## **BID Addendum #1**

**Project:** SFC-23N002; OSSB OSSD Energy Project  
**Date:** 5/1/2025  
**Location:** Ohio School for the Deaf  
**By:** Michael Chow, Metro CD Engineering

**LIGHTING PLAN,  
1'ST FLOOR,  
ZONE C**

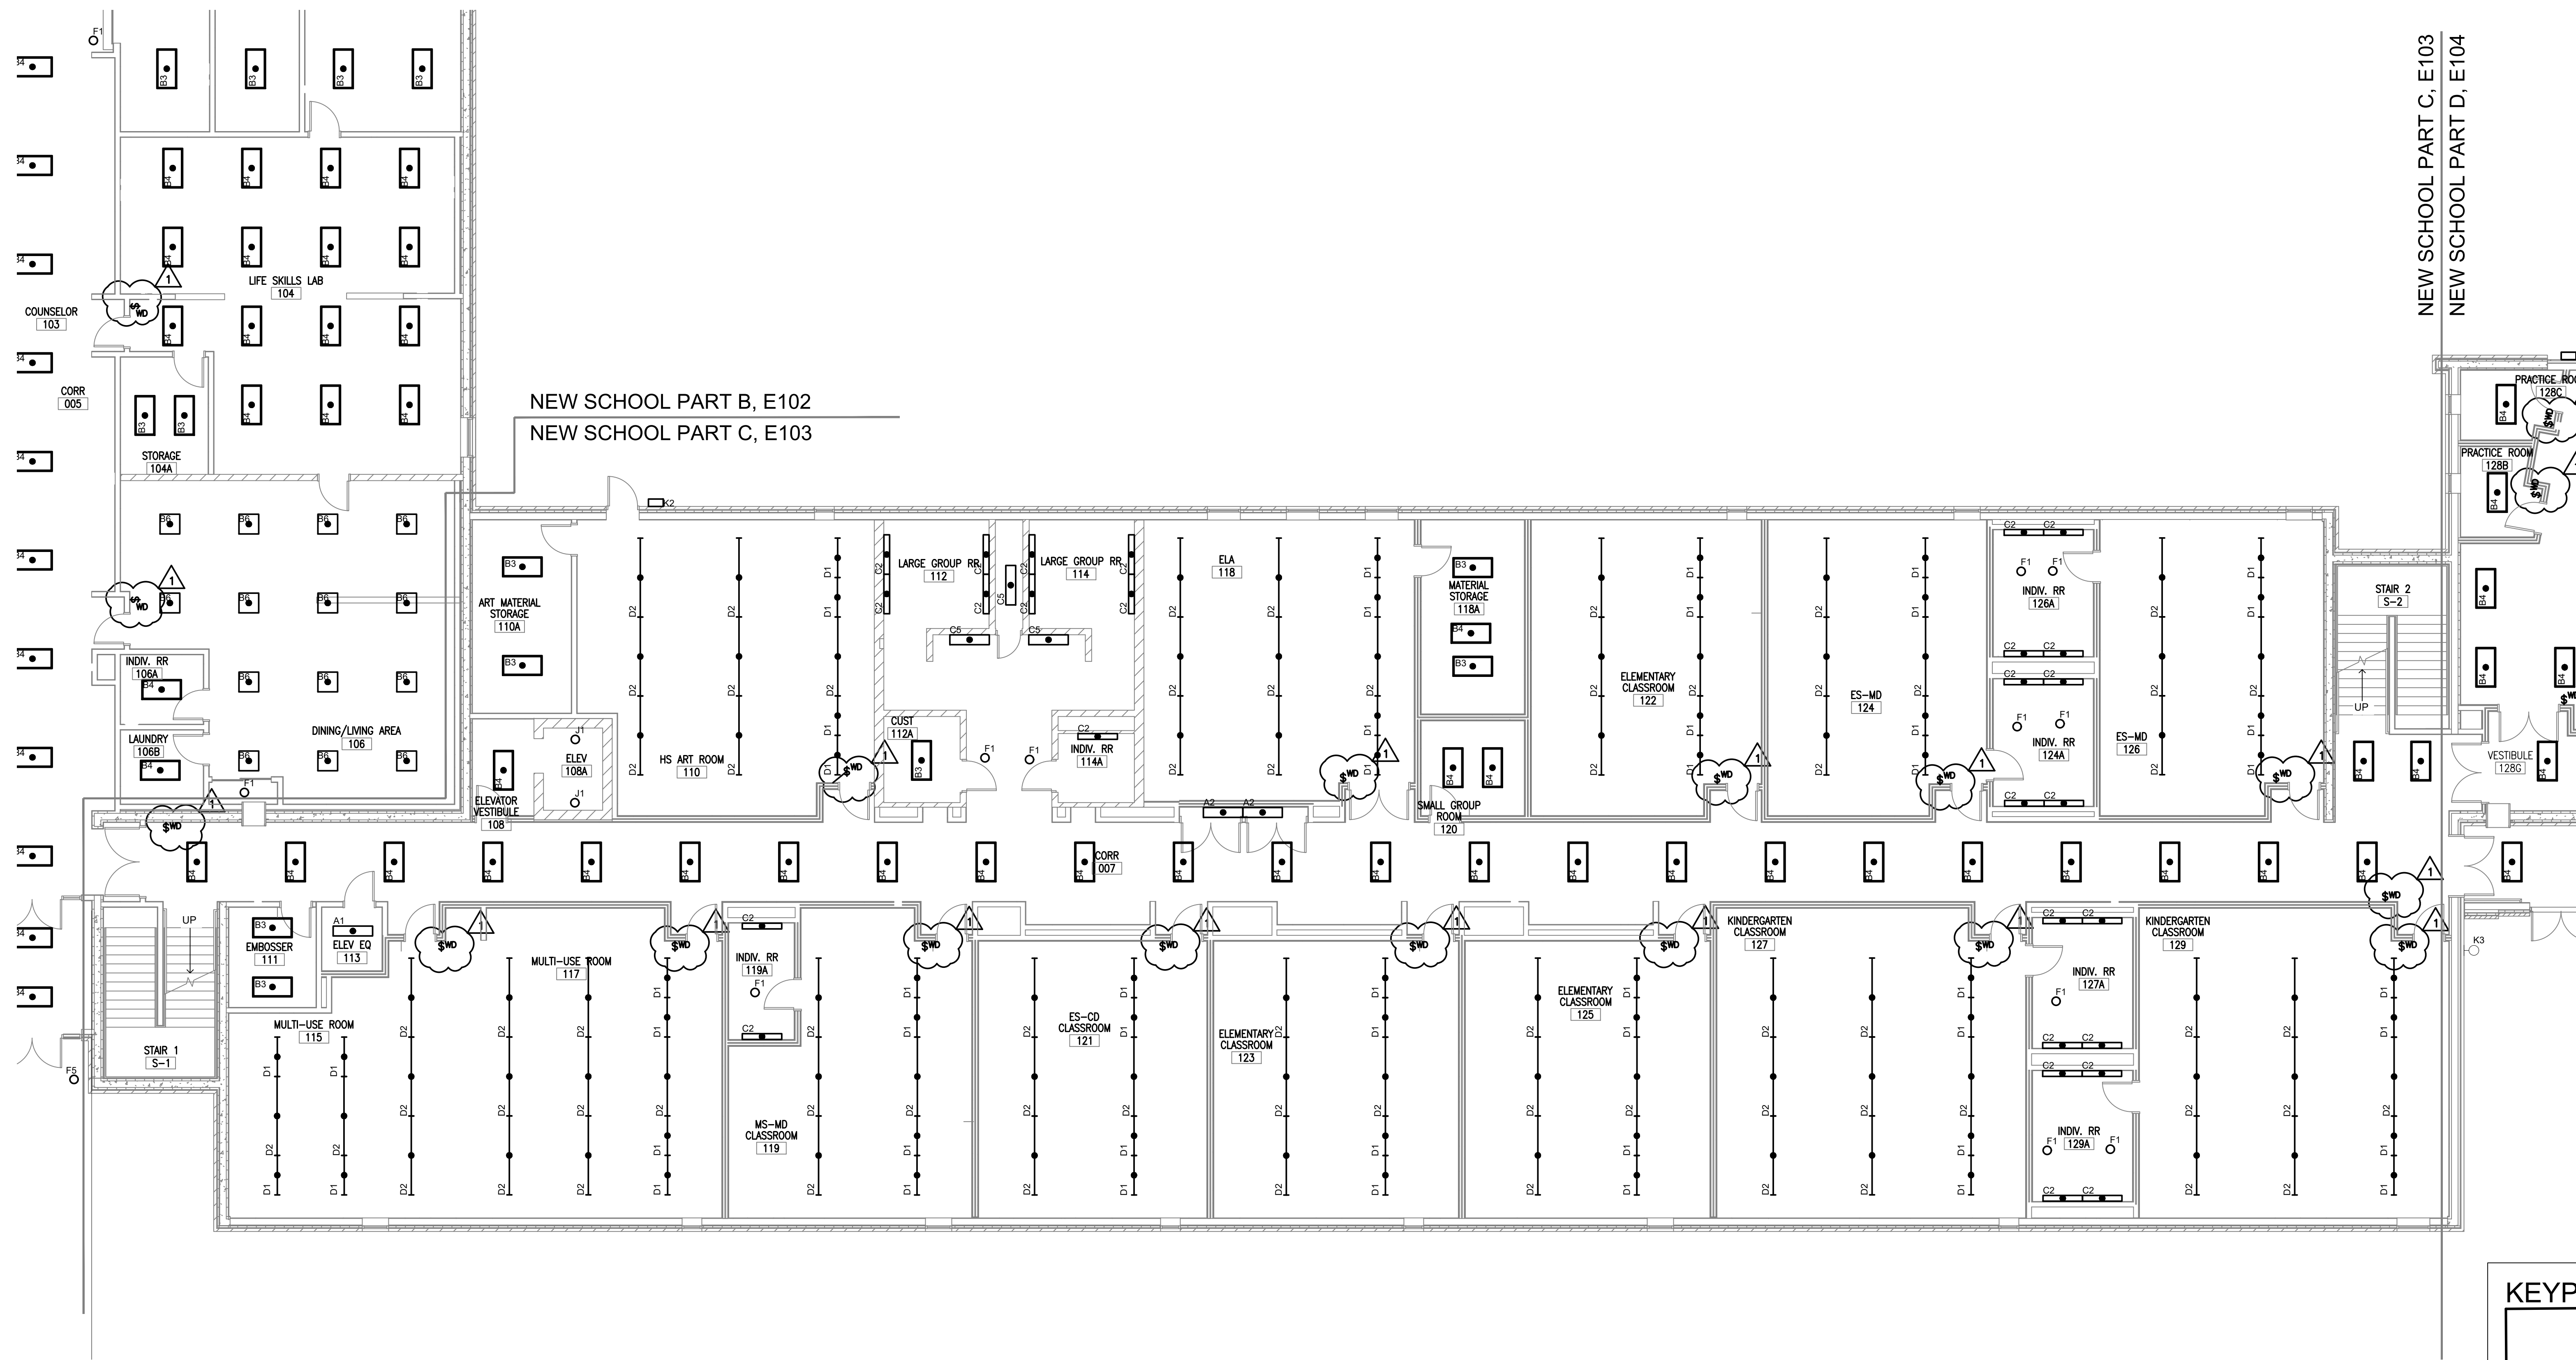
7. Drawing Changes:
  - a. Drawing changes because of pre-bid meeting and follow up direction, scope clarification and scope additions by OFCC & OSSB/OSSD O&M are as listed above under "Pre-Bid Meeting walk-through.
  - b. OSSB New School: Drawings E101, E102, E103, E104 & E105 are revised to show wireless dimming wall-switches in all areas where required.
  - c. OSSB Old School: Drawings E101, E102, E103, E104, E105, E106 & EE107 are revised to show wireless dimming wall-switches in all areas where required.

**A LIGHTING PLAN, OLD SCHOOL FIRST FLOOR ZONE A**  
E102 1/8" = 1'-0"

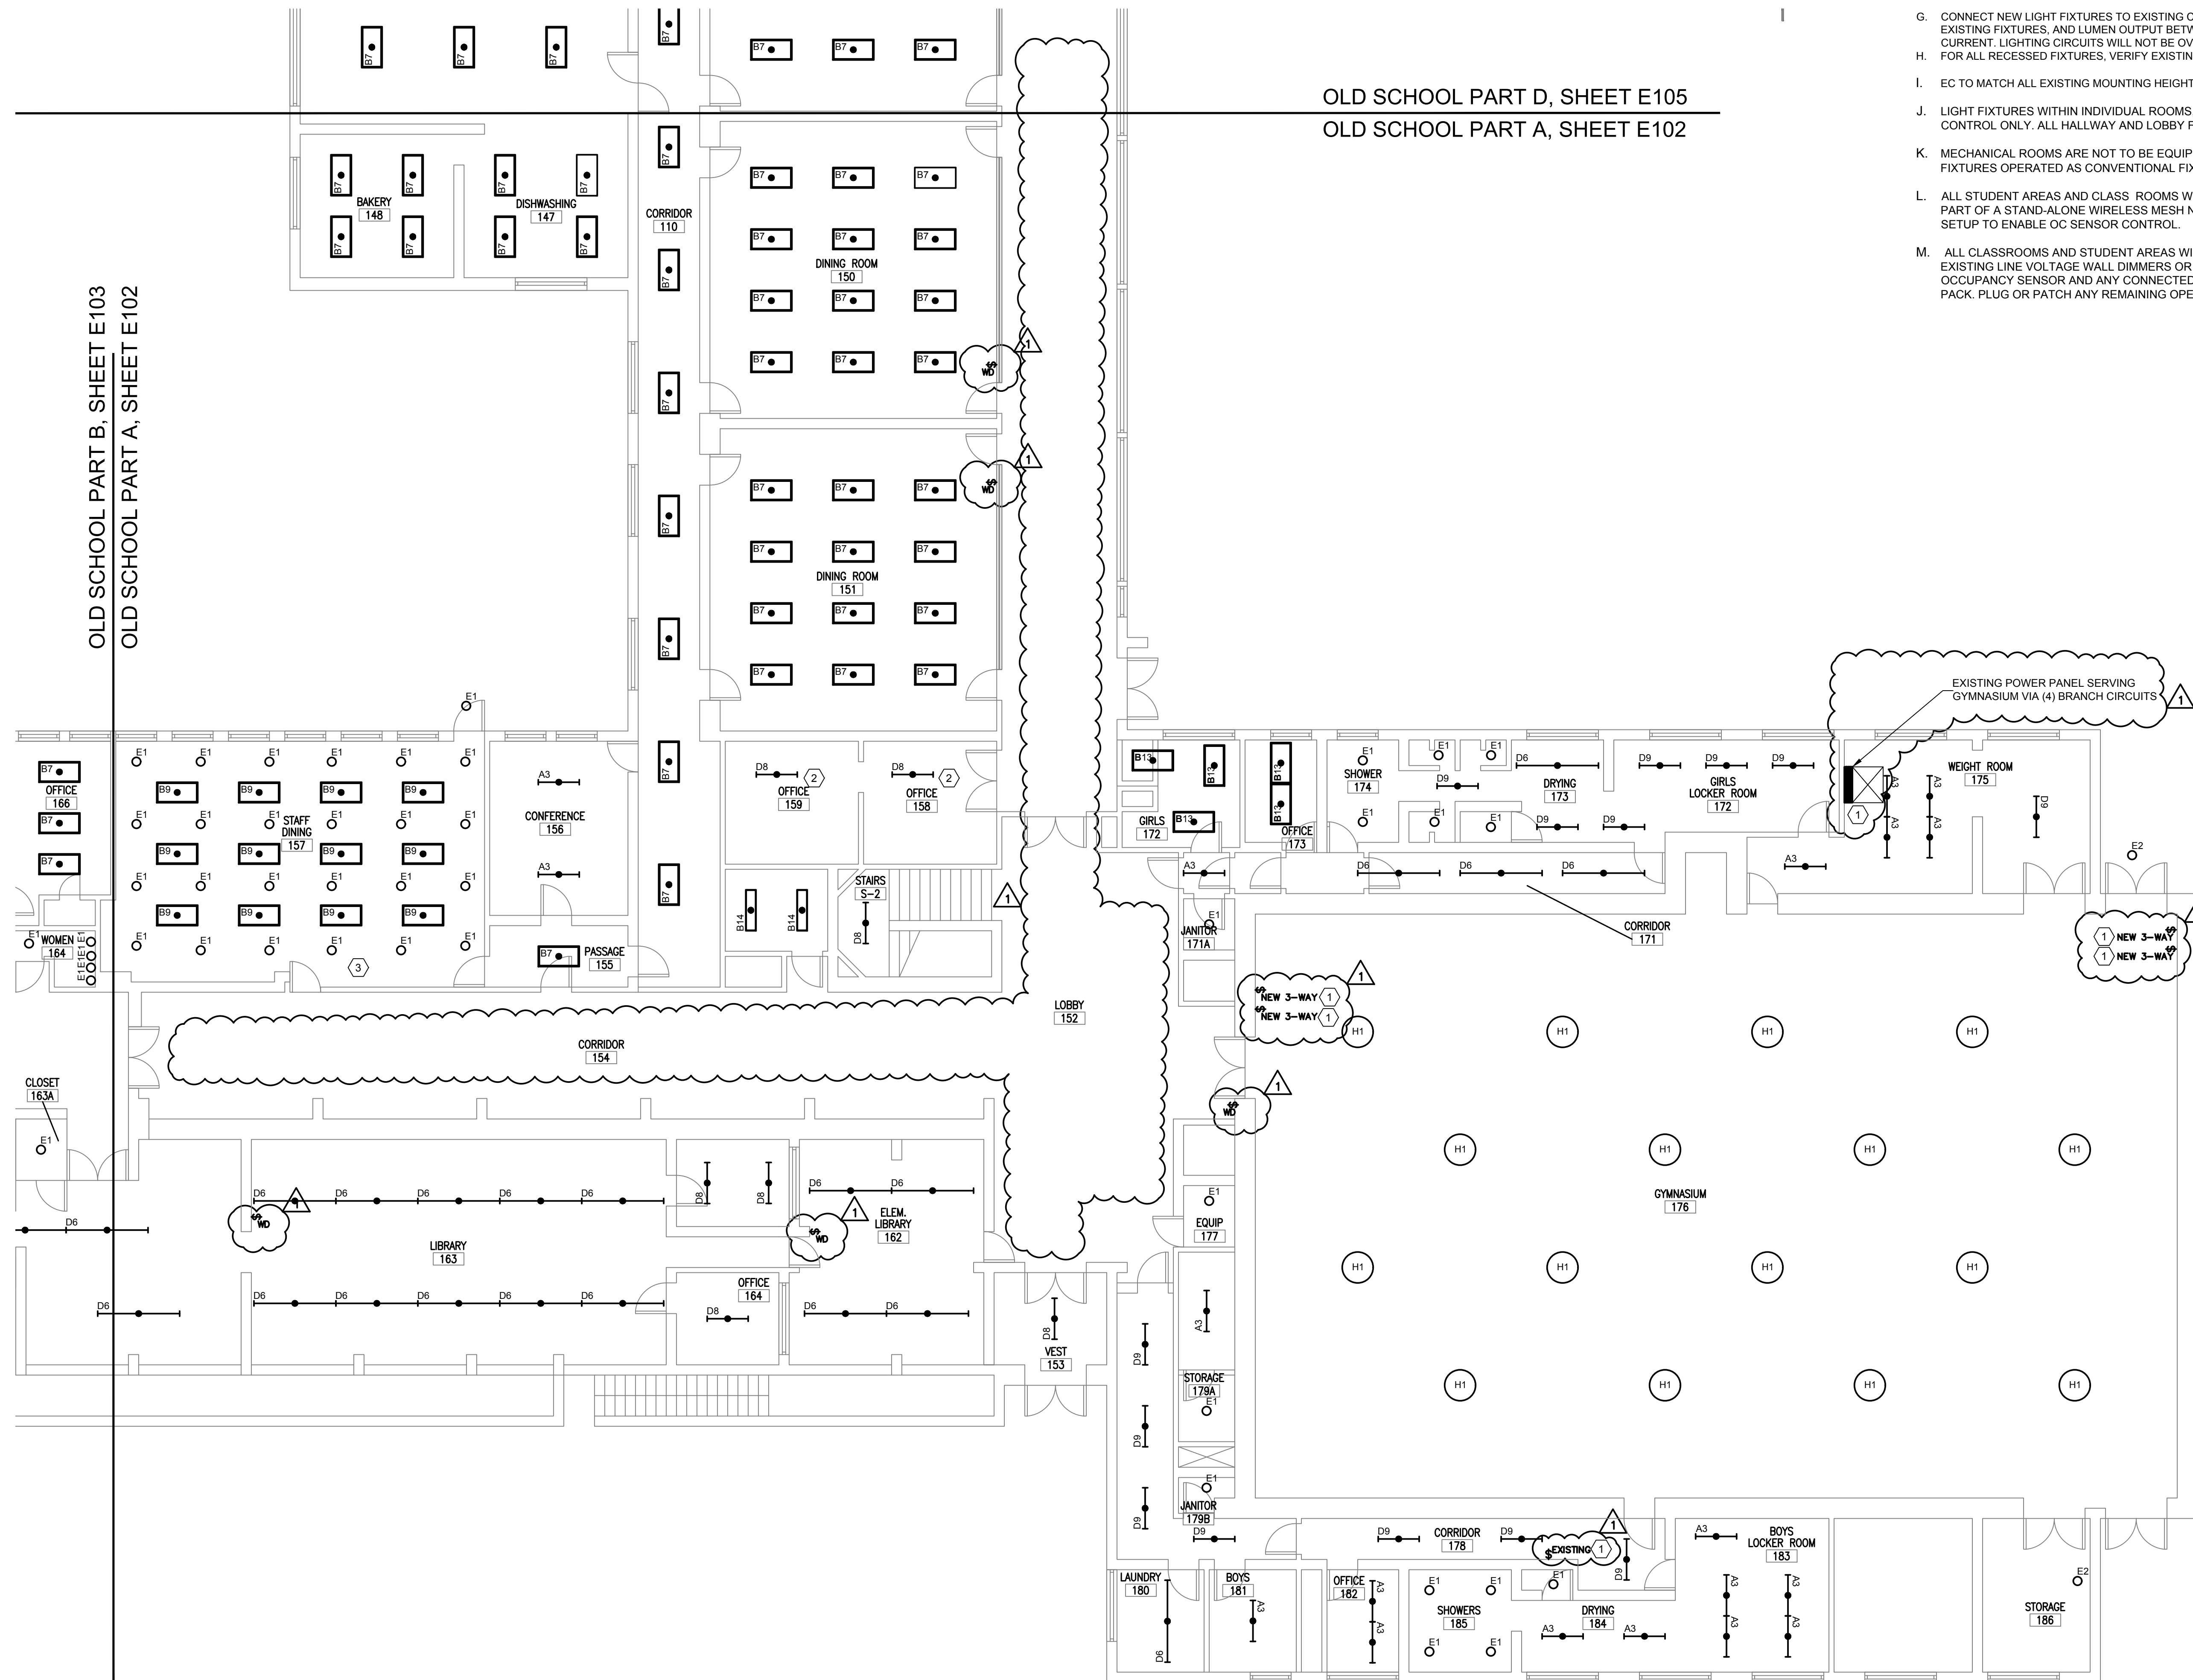
- c. OSSB Old School: Added to scope of work Gymnasium (room 176) sheet E102 switching scope of work. Scope of work includes installation of (2) toggle type wall switches to relocate & replace (1) existing switch and add local switching where currently switching is performed using power panel breakers. Power panel located in an adjacent room.

CODED NOTES	
1	REVISE GYMNASIUM SWITCHING: DEMO EXISTING TOGGLE TYPE WALL SWITCH, EXTEND NEUTRAL, HOT & TRAVELER TO NEW SWITCH LOCATION CONTROLLING FRONT HALF OF GYM. PROVIDE BRANCH CIRCUIT CONDUCTORS AND CONDUIT FROM EXISTING POWER PANEL TO NEW SWITCH LOCATION SERVING REAR HALF OF GYMNASIUM. PROVIDE NEW TOGGLE TYPE WALL SWITCHES PER SYMBOL LEGEND. PROVIDE CONDUIT & CONDUCTOR FROM SWITCH TO REAR GYMNASIUM LIGHT FIXTURES.
2	FIXTURES HAVE CENTER BASKET BLACK LIGHT TUBE PRIOR TO REPLACEMENT. CONFIRM WITH FACILITIES ANY SPECIFIC LIGHTING REQUIREMENTS.
3	DEMO EXISTING DIMMER SWITCHES. PROVIDE AND INSTALL NEW WIRELESS MESH ENABLED DIMMING SWITCHES. USE EXISTING SWITCH LEG TO POWER NEW DIMMER.

**A LIGHTING PLAN, OLD SCHOOL FIRST FLOOR ZONE B**  
**E103**  
 1/8" = 1'-0"

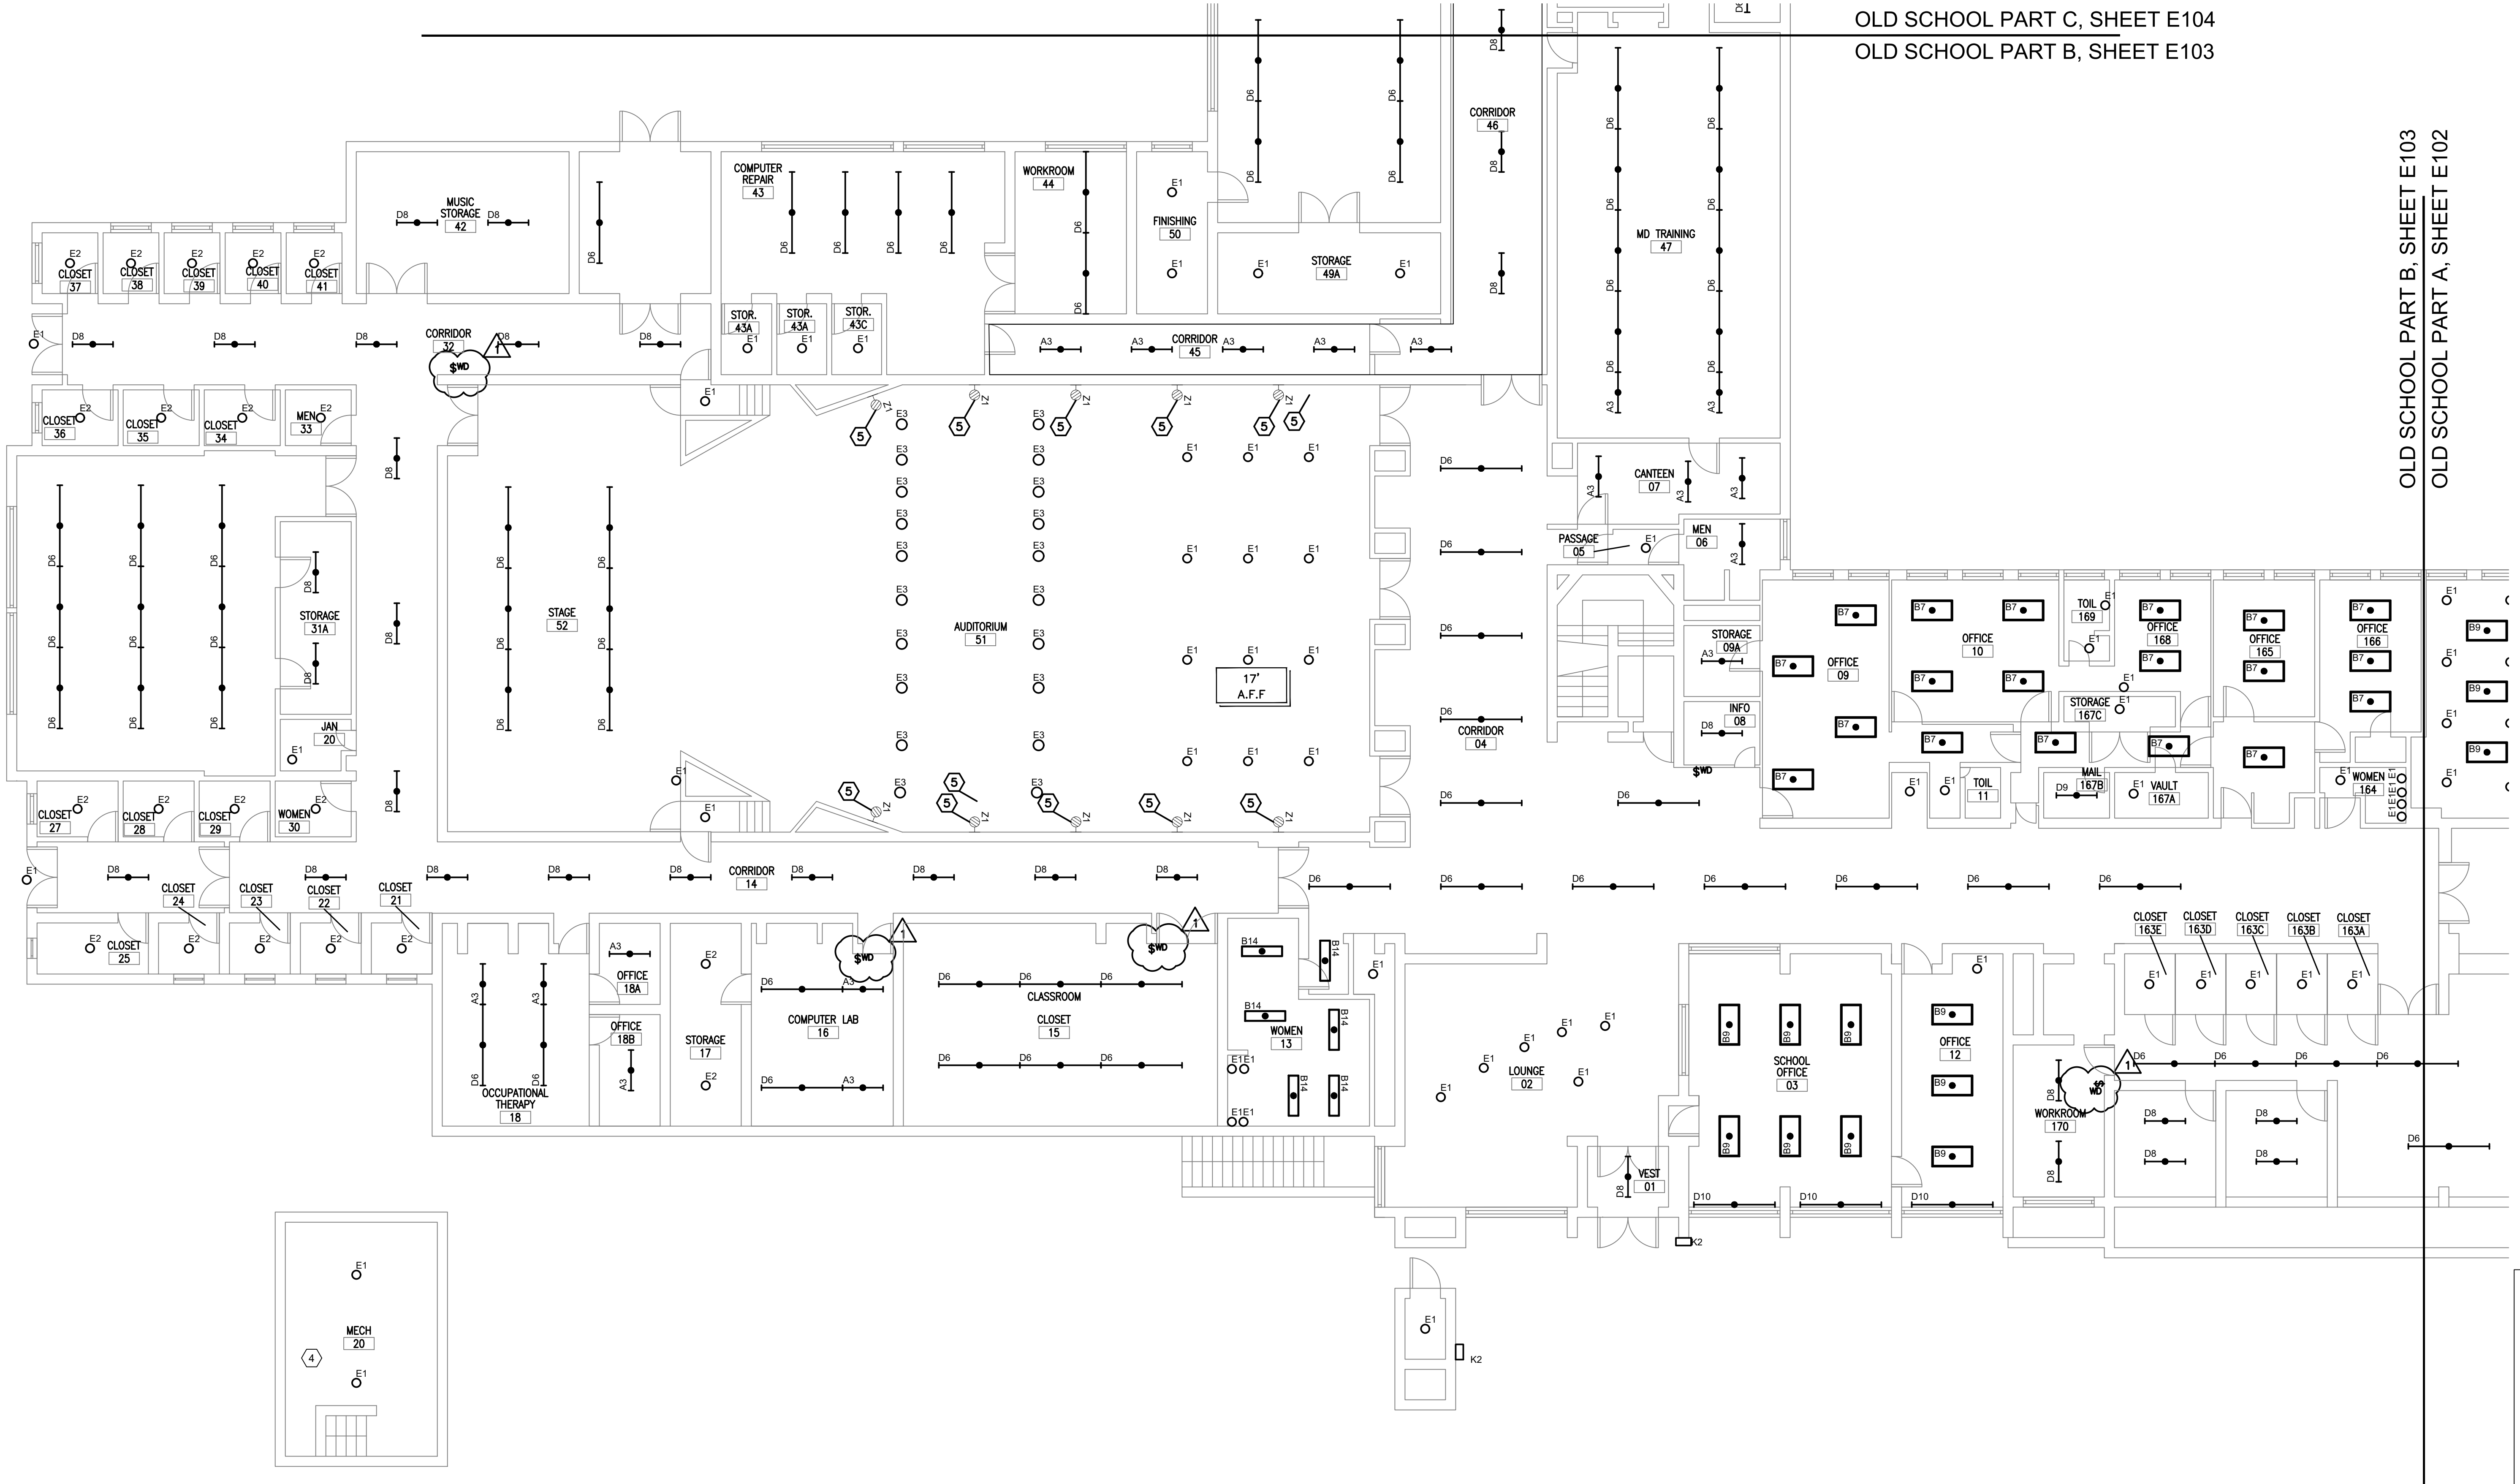
- i. OSSD Old School common areas & hallways: Removed from scope of work existing fixtures O&M reports as previously upgraded to LED type. Drawings E102, E103,
